Docket Number:	18-IRP-01
Project Title:	Integrated Resource Plan
TN #:	229117
Document Title:	Staff Paper - Review of Burbank Water and Power's 2019 Integrated Resource Plan
Description:	N/A
Filer:	Harinder Kaur
Organization:	California Energy Commission
Submitter Role:	Commission Staff
Submission Date:	7/29/2019 11:44:33 AM
Docketed Date:	7/29/2019

Review of Burbank Water and Power's 2019 Integrated Resource Plan

July 2019 | CEC-200-2019-009

Figure 1: Burbank and Energy Commission Energy Forecasts 2018-2030 (GWh)

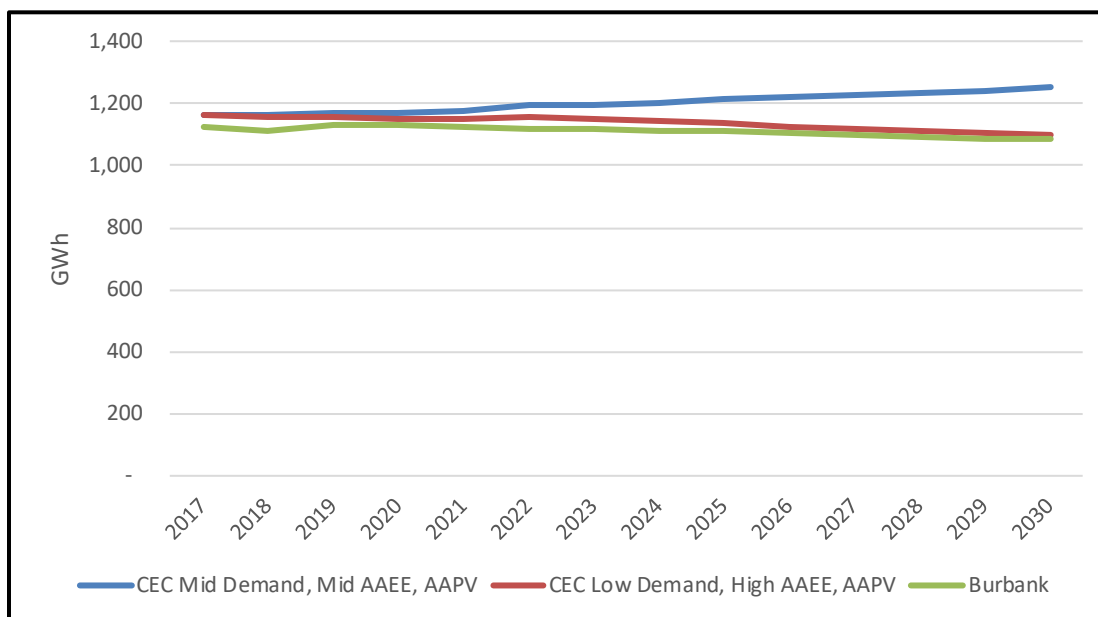
Figure 1 compares Burbank’s energy forecast with the Energy Commission’s forecasts, showing that Burbank’s energy forecast is lower than the Energy Commission’s mid demand forecast and almost identical to the low demand forecast.⁷ Burbank’s energy forecast shows a slight decrease in demand, with an average annual growth rate of roughly -0.3 percent from 2019 to 2030, compared to an increase in demand, with a growth rate of roughly 0.6 percent in the Energy Commission’s mid demand forecast. The difference between the Burbank and the Energy Commission mid demand forecast is 37 gigawatt-hour (GWh) in 2019, and grows to 164 GWh by 2030. The decrease in Burbank’s forecasted energy demand likely comes from its efforts to reduce annual energy and peak capacity needs through energy efficiency, distributed generation, time of use rates, and demand response programs. This also may explain why Burbank’s forecast is closer to the Energy Commission low demand forecast, which reflects higher levels of demand reduction.

Figure 2: Burbank and Energy Commission Peak Forecasts 2018 — 2030 (MW)

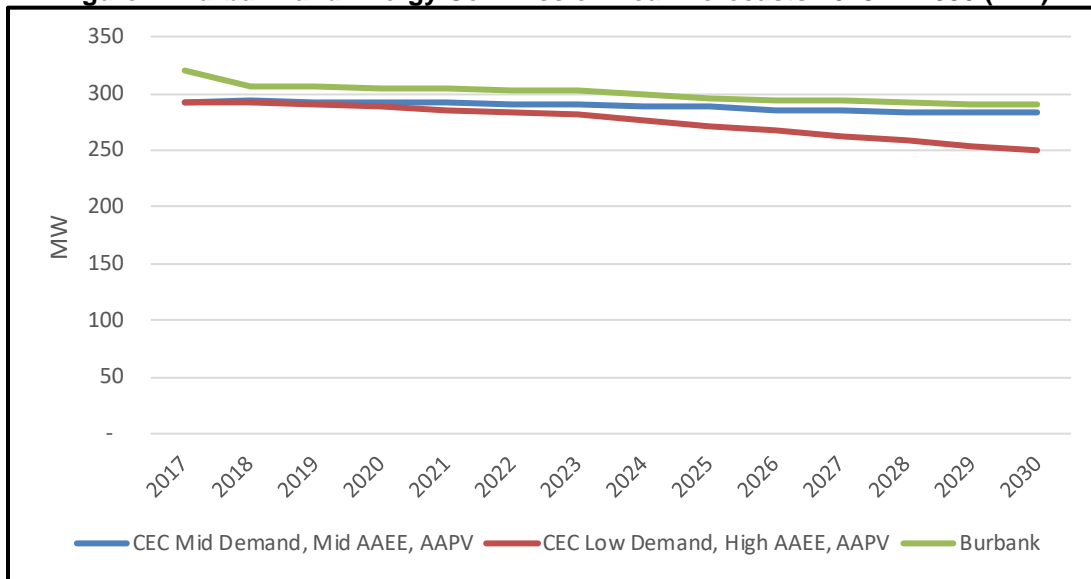
Burbank’s peak forecast is higher than the Energy Commission’s mid and low demand peak forecasts as shown in **Figure 2**. The peak forecasts show small annual average decreases, -0.46 percent for Burbank and -0.25 percent for the Energy Commission mid demand forecast. Burbank’s peak forecast is higher than the Energy Commission’s peak forecast in each year of the planning period. In 2019, the difference is 14 megawatt (MW) (5 percent), and by 2030, this difference decreases to 6 MW or (2 percent).

Figure 3: Sources of Renewables Portfolio Standard Eligible Energy 2019 — 2030 (MWh)

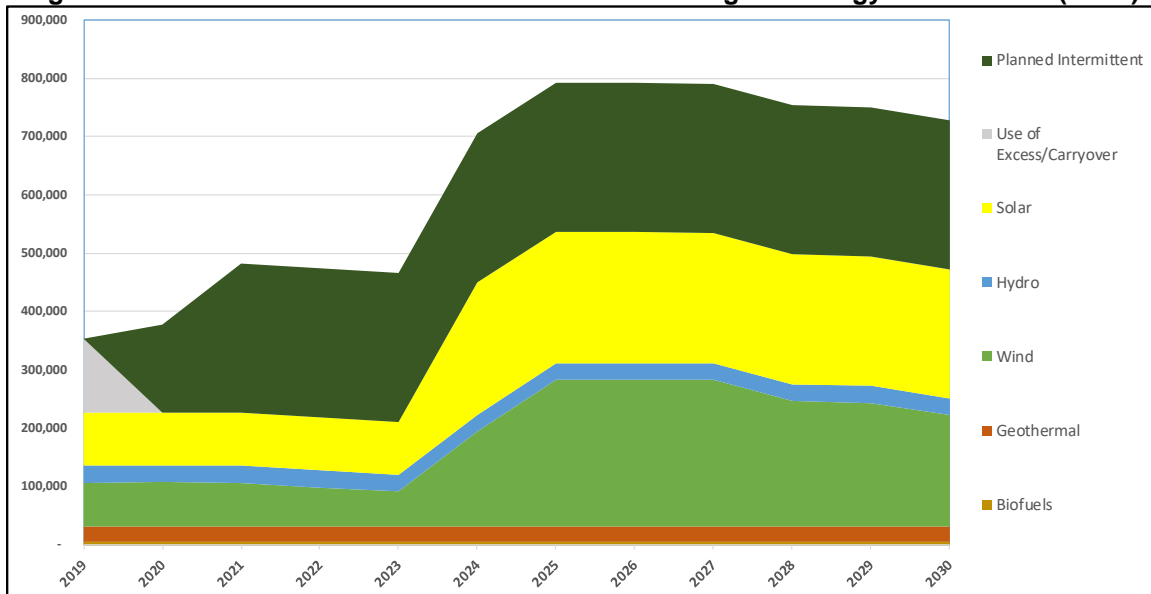
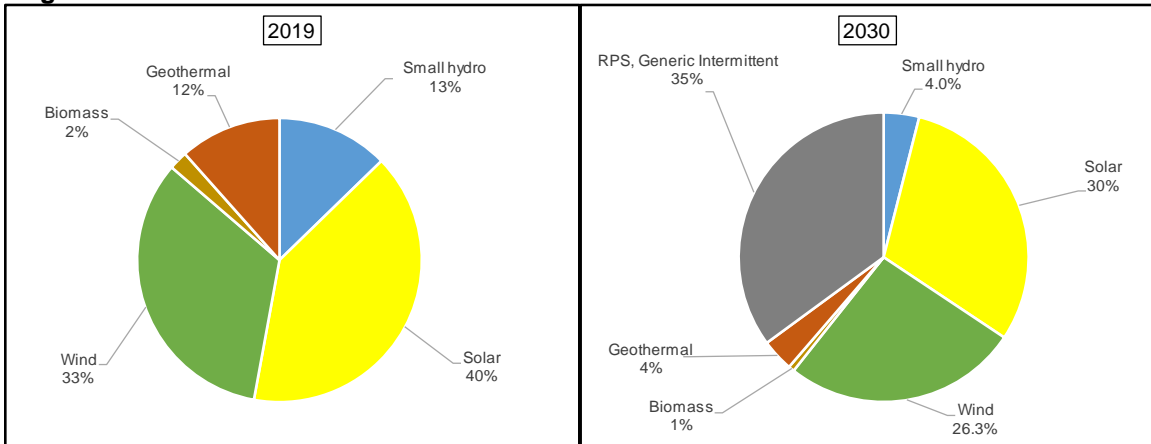
The utility expects to use its energy storage resources to help integrate increased amounts of renewable resources and address over-generation and ramping needs from solar. **Figure 3** and **Figure 4** show the increase in renewable generation from 2019 to 2030. Burbank expects to reach the following RPS levels over the planning period:

Figure 5: Burbank Portfolio Comparison for 2019 and 2030

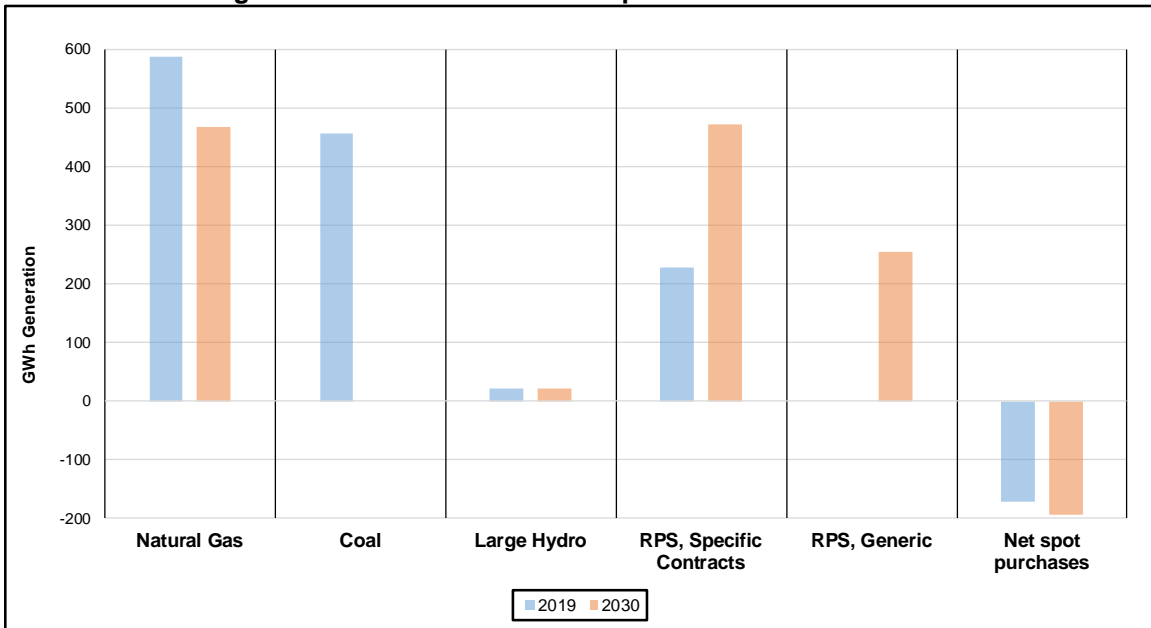
By 2030, Burbank will have transitioned from coal to a portfolio emphasizing solar PV, wind, energy storage, and spot market purchases and sales of energy. This portfolio also maintains the same level of output for the utility’s existing renewable and GHG-free resources such as geothermal, nuclear, biofuels, and hydroelectric.

Figure 5 shows a comparison of the energy mix by resource in Burbank’s preferred portfolio in 2019 and 2030.
